MONTGOMERY COUNTY HISTORIC PRESERVATION COMMISSION
STAFF REPORT

Address:	5633 Lambeth Rd., Bethesda	Meeting Date:	4/6/2022
Resource:	Contributing Resource Greenwich Forest Historic District	Report Date:	3/30/2022
Applicant:	Jane & Steve Jepson David Merrick, Agent	Public Notice:	3/23/2022
Review:	HAWP	Tax Credit:	n/a
Permit No.:	985601	Staff:	Dan Bruechert
Proposal:	Fenestration alteration, siding replacement, painting unpainted masonry

Figure 1: 5633 Lambeth Rd.

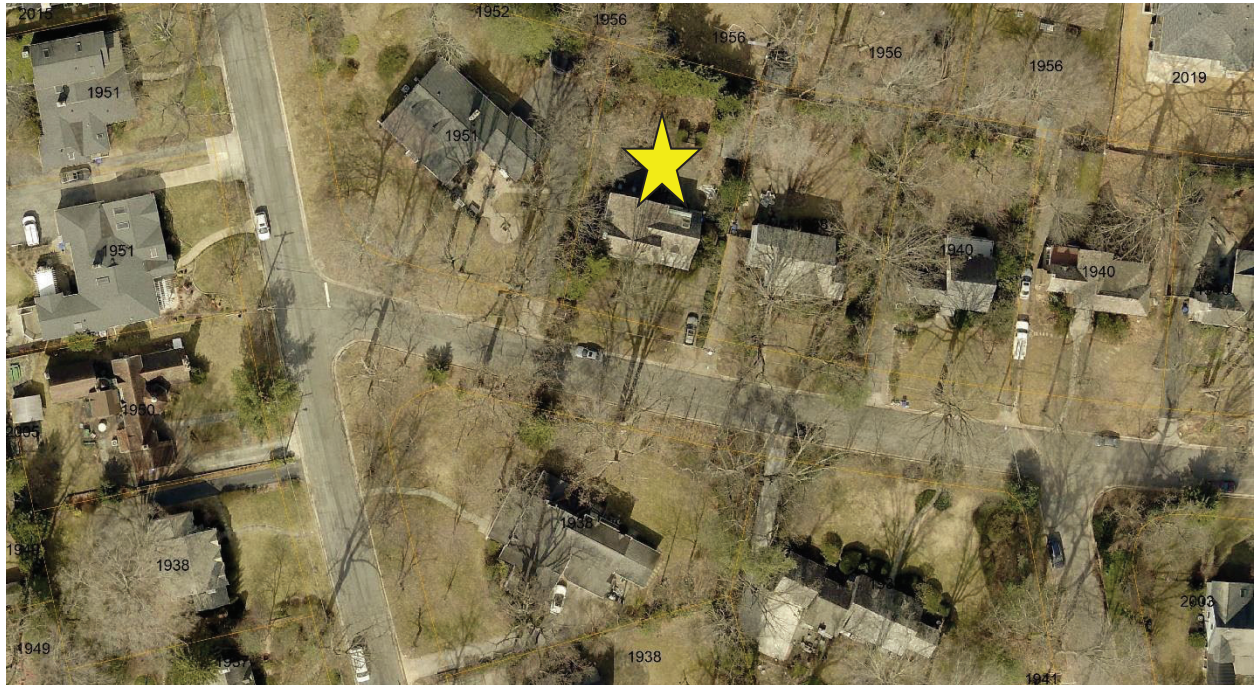
The subject property is a two-story brick Colonial Revival with a slate gambrel roof. To the right, the original porch has been enclosed with large picture windows and T1-11 siding. The applicant proposes to remove the picture windows and install new double-hung aluminum clad windows with shutters, replace the T1-11 and wood siding with fiber cement siding, and paint the house. Staff finds the work will not have a significant impact on the house or character of the district and recommends the HPC approve the HAWP.

Staff recommends the HPC **approve** the HAWP.

Existing Partial Front Elevation

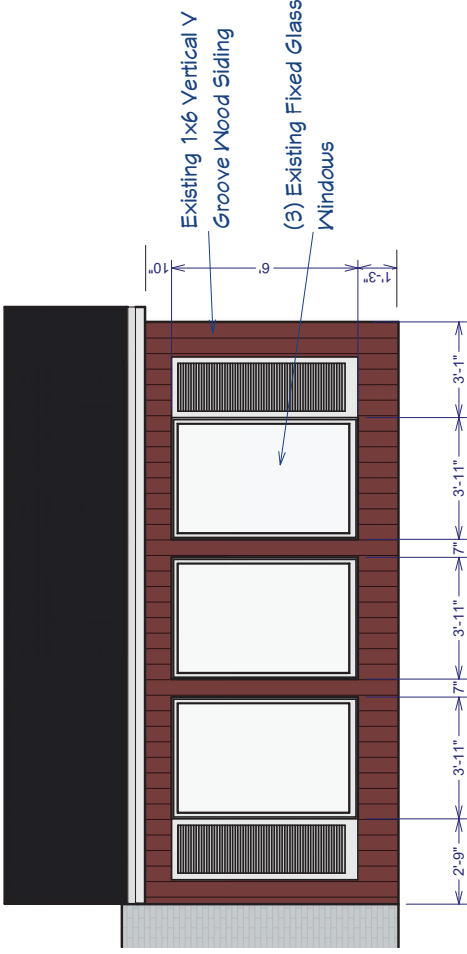
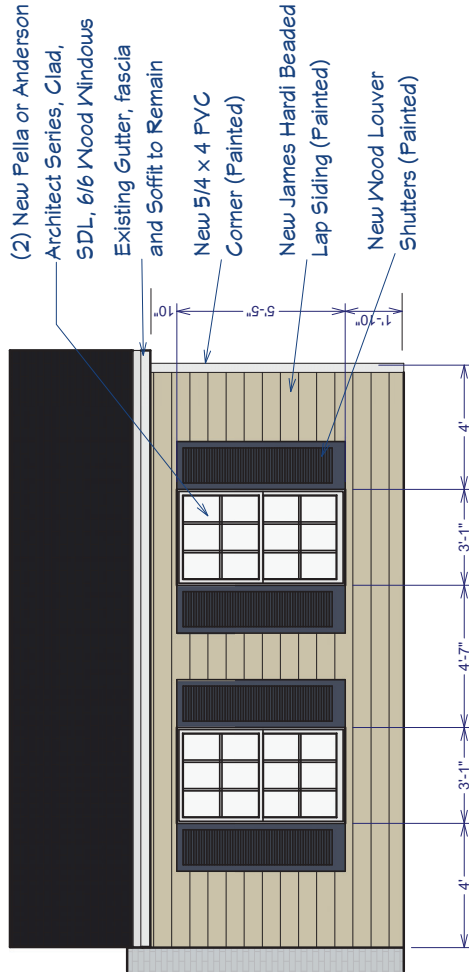
On the right side of the house, historically, there was an open porch. Sometime before the district was established, the porch was enclosed with three large picture windows and T-11 siding. The applicant proposes to remove the windows and replace them with two six-over-six aluminum clad SDL windows with fiber cement siding in a 7" (seven inch) exposure.

Staff finds the proposed changes will not have a significant impact on the historic character of the house, as the alterations are non-historic. Staff finds the six-over-six windows match the configuration of the existing windows and are compatible with Colonial Revival architecture. Staff additionally finds the proposed siding will replace non-historic siding, and while the fiber cement siding has a narrower shadow line than wood siding, Staff finds it is a significant improvement over the T1-11. Finally, Staff finds the paired louvered wood shutters and consistent with the shutters on the first floor and are an appropriate feature under the *Design Guidelines* and 24A-8(b)(2).

Staff finds painting the fiber cement siding, windows, and shutters is all in-kind work and does not require a HAWP. The applicant proposes painting the exterior brick as part of this HAWP. The HPC considered and denied a similar HAWP application in Greenwich Forest in October 2021.¹ In that case, the applicant sought approval to paint the historic brick house and the HPC determined that painting the historic brick would not preserve the house as a recognizable entity as required for building additions proposals under guideline D4. This proposal differs in that it does not include a building addition, so the reasoning in the October 2021 HAWP does not apply in this instance.

Painting an unpainted brick surface is not a recommended historic preservation practice, primarily because it obscures the historic fabric and can rarely be removed in its entirety without damaging the brick. Staff acknowledges that painting the brick would contravene Standard 2, however, the *Greenwich Forest Design Guidelines* provide more flexibility to homeowners; similarly, the HPC's Executive Regulations for 24A require that when there is a conflict between the Standards and local guidelines, the local guidelines control.

Staff recommends that the Commission **approve** the HAWP application; under the Criteria for Issuance in Chapter 24A-8(b)(2) and (d), and the *Greenwich Forest Historic District Design Guidelines*, having found that the proposal will not substantially alter the exterior features of the historic resource and is compatible in character with the surrounding district and the purposes of Chapter 24A;
